BOARD OF COUNTY COMMISSIONERS
ORANGE COUNTY, FLORIDA

ADDENDUM NO. 4 / IFB NO. Y17-711-PH

SOUTH WATER RECLAMATION FACILITY FATS OILS AND GREASE (FOG)
AND SEPTAGE RECEIVING STATION

ORANGE COUNTY UTILITIES
 SOUTH WATER RECLAMATION FACILITY FOG & SEPTAGE RECEIVING STATIONS
 MECHANICAL
 EXISTING SEPTAGE RECEIVING STATION AND DEMOLITION

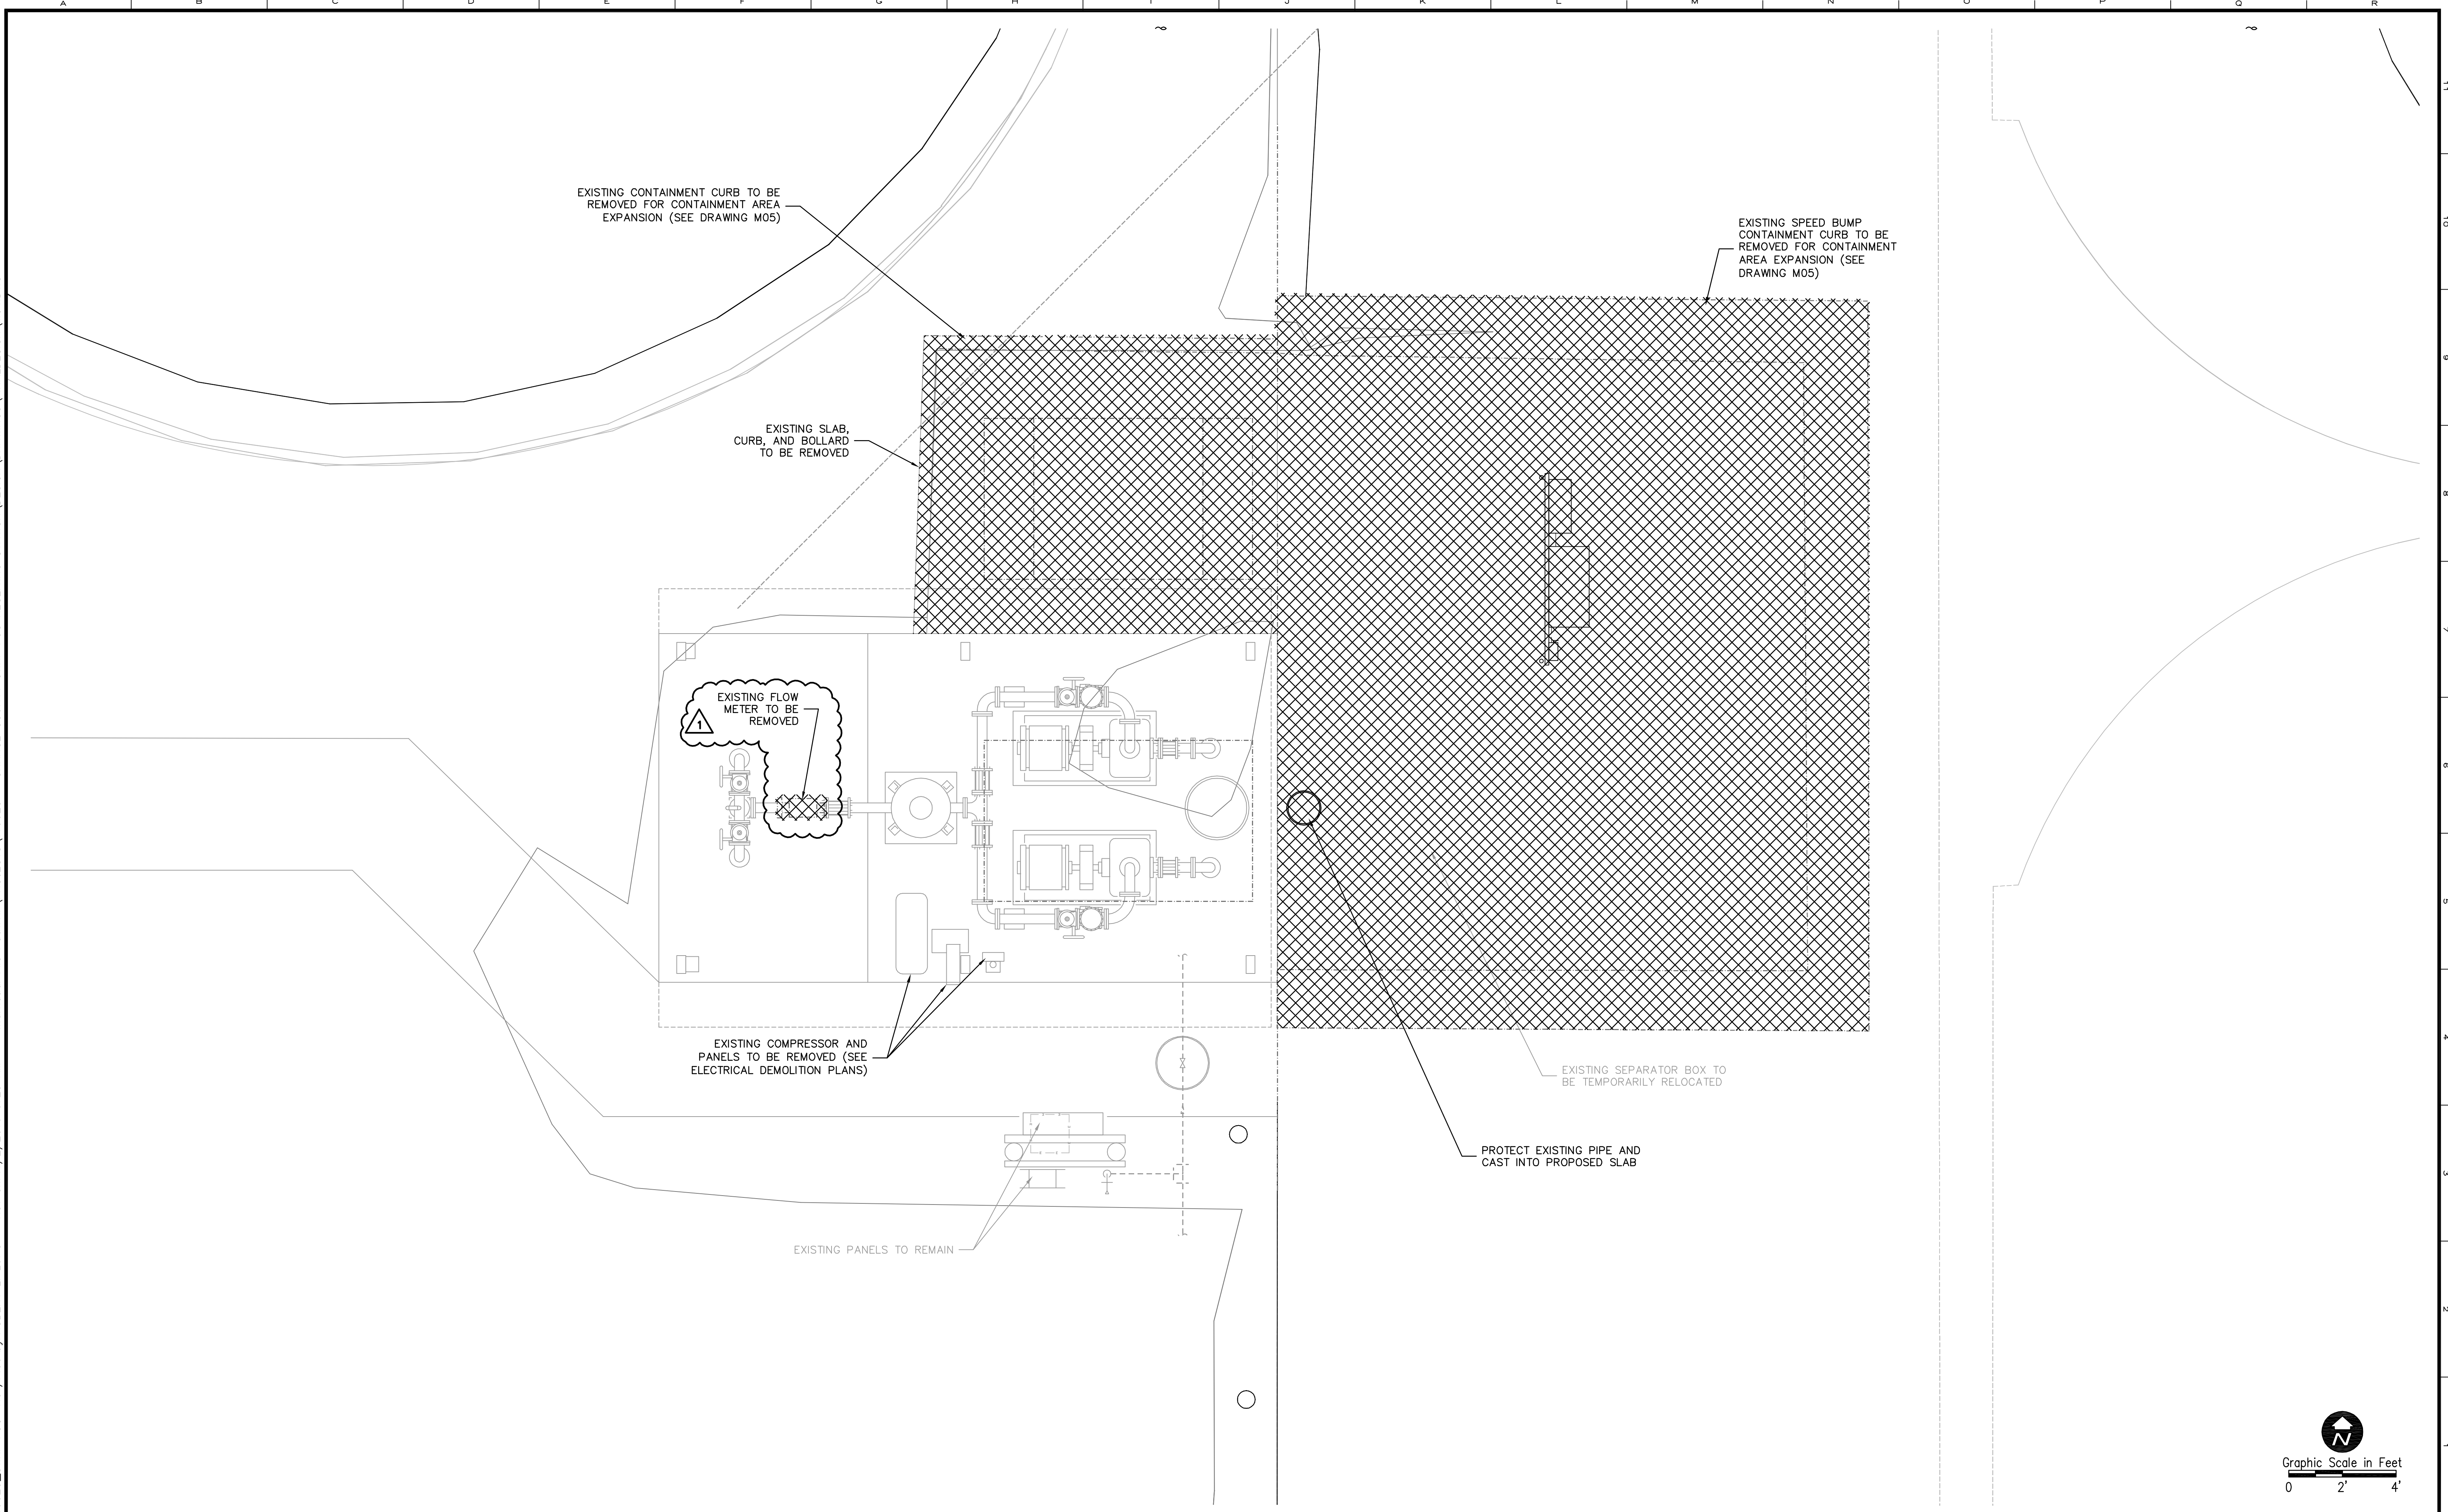
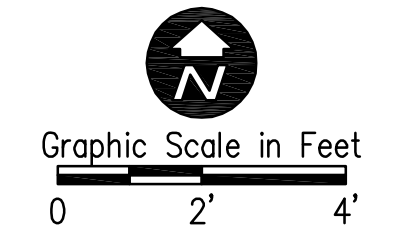
- 1. See revised drawings M01 as attached**
- 2. See revised drawing C03 as attached.**
- 3. Existing septage receiving flow meter to be replaced. Revised drawings M04 and M05 are attached.**
- 4. Drawing E02: Replace Drawing E02 in its entirety with the attached Drawing E02 issued as part of this addendum.**
- 5. Drawing E03: Replace Drawing E03 in its entirety with the attached Drawing E03 issued as part of this addendum.**
- 6. Drawing E04: Replace Drawing E04 in its entirety with the attached Drawing E04 issued as part of this addendum.**
- 7. Drawing E07: Replace Drawing E07 in its entirety with the attached Drawing E07 issued as part of this addendum.**
- 8. Drawing E08: Replace Drawing E08 in its entirety with the attached Drawing E08 issued as part of this addendum.**

ORANGE COUNTY UTILITIES
 SOUTH WATER RECLAMATION FACILITY FOG & SEPTAGE RECEIVING STATIONS
 INSTRUMENTATION & CONTROLS
 PARTIAL NETWORK BLOCK DIAGRAM

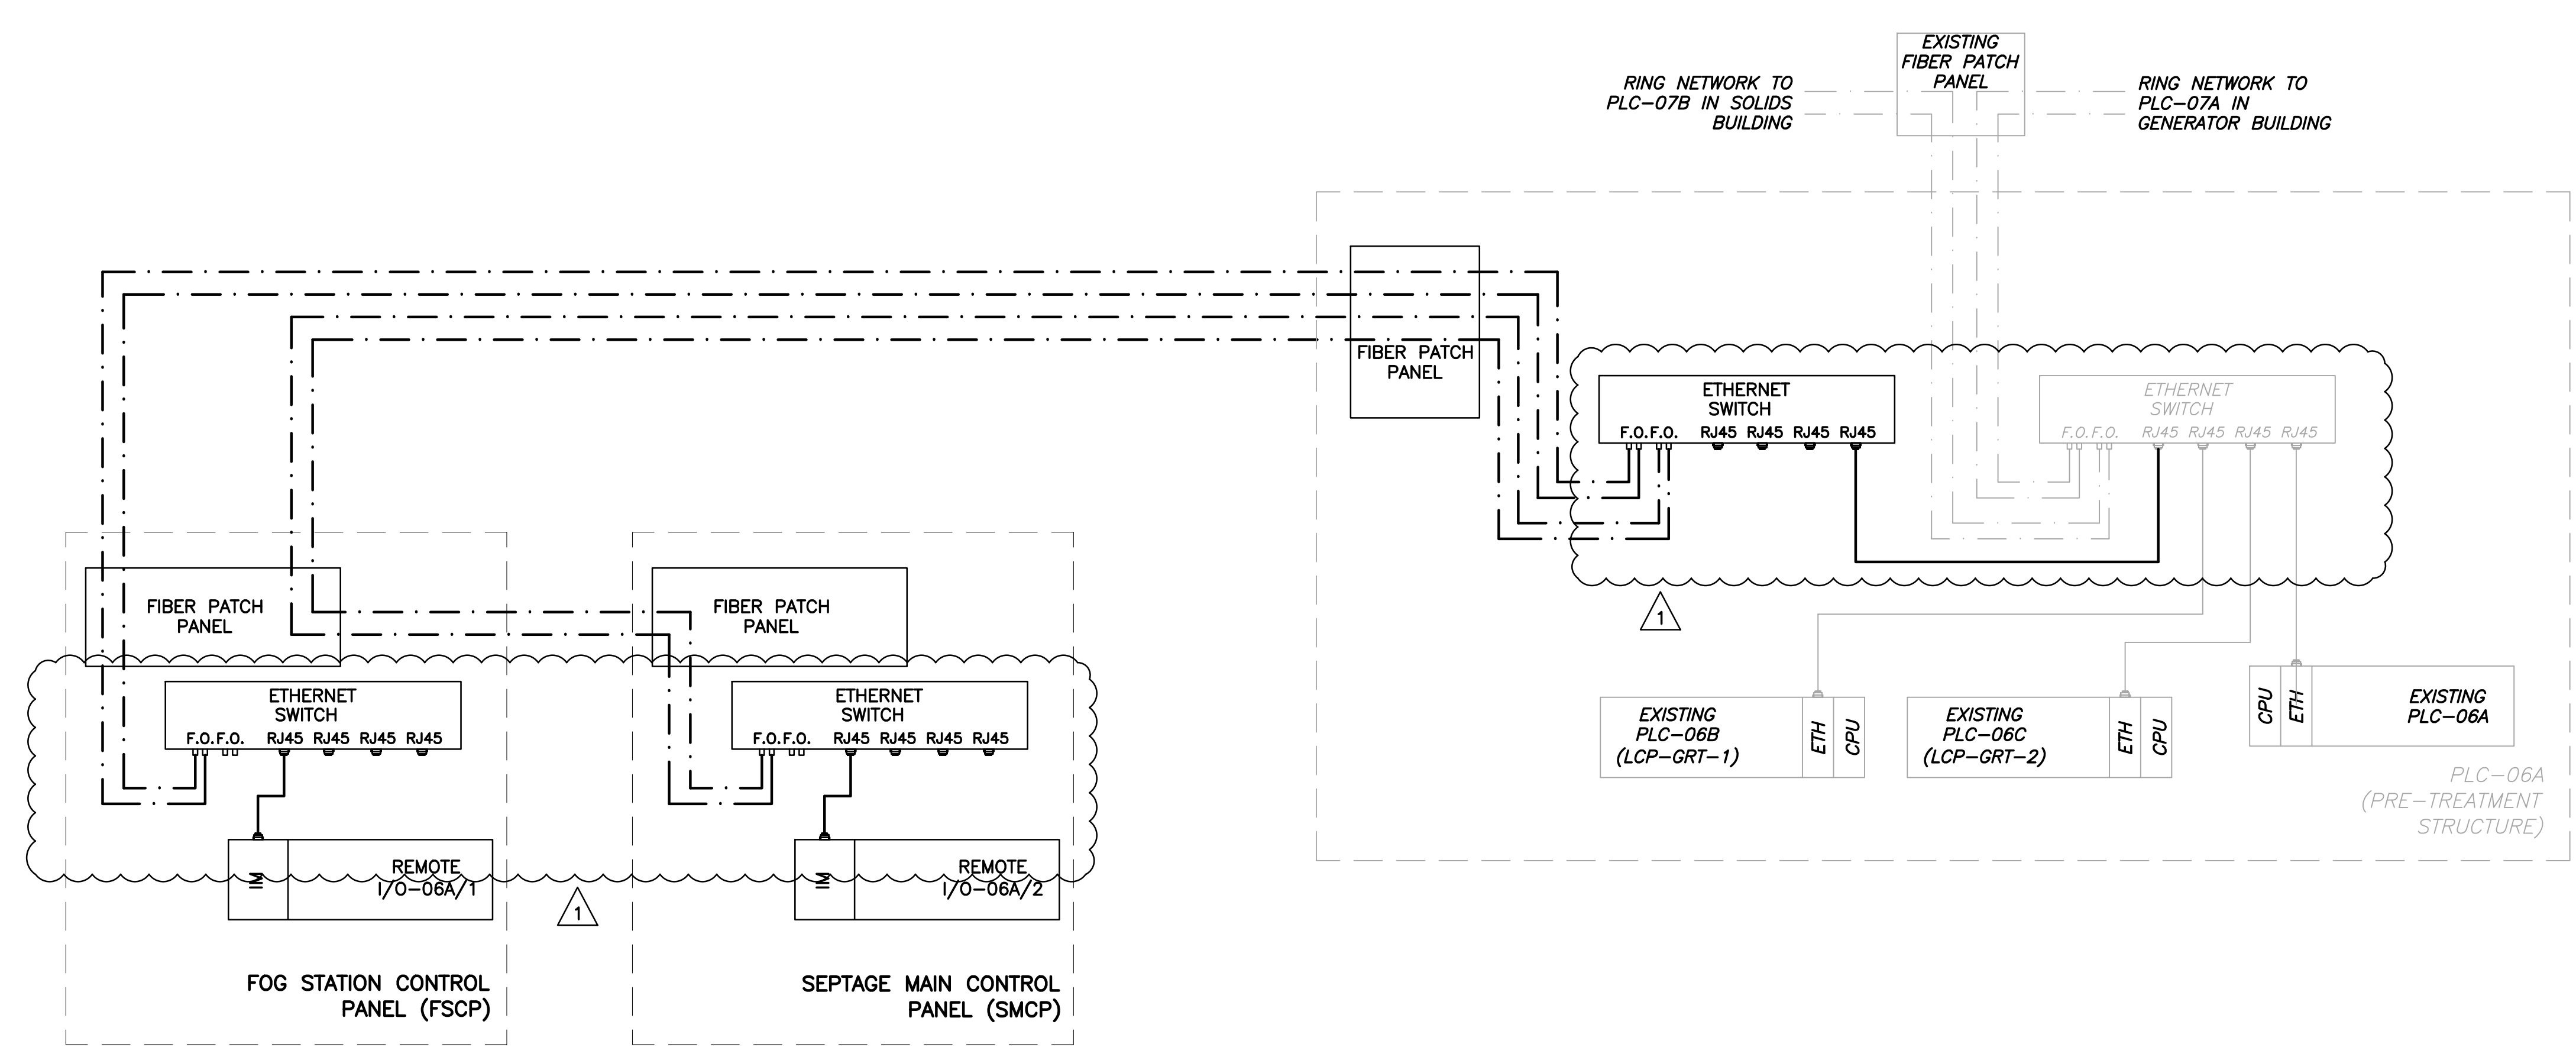
18. Q. The Phase V improvements at SWRF already include a new plant network switch for PLC-6A. Could a second switch of the same type (X304-2FE) be added to PLC-6A to separately handle the Remote I/O fiber network? Adding an X304-2FE is about \$1400, adding the specified XM308M with required multi-media modules is about \$6000.

19. Q. The network drawing (Dwg. No. 105, Sheet 48) indicates a fiber optic run that goes all the way to the Interface Module on the Remote I/O rack. I believe this was an option with S7-300 hardware, but is not an option for the S7-1500 family. Should an additional fiber optic network switch (X304-2FE) be added to both Remote I/O panels?

A. Network drawing has been revised to add the new switch in PLC-06A.

A. Network drawing and specifications have been revised.
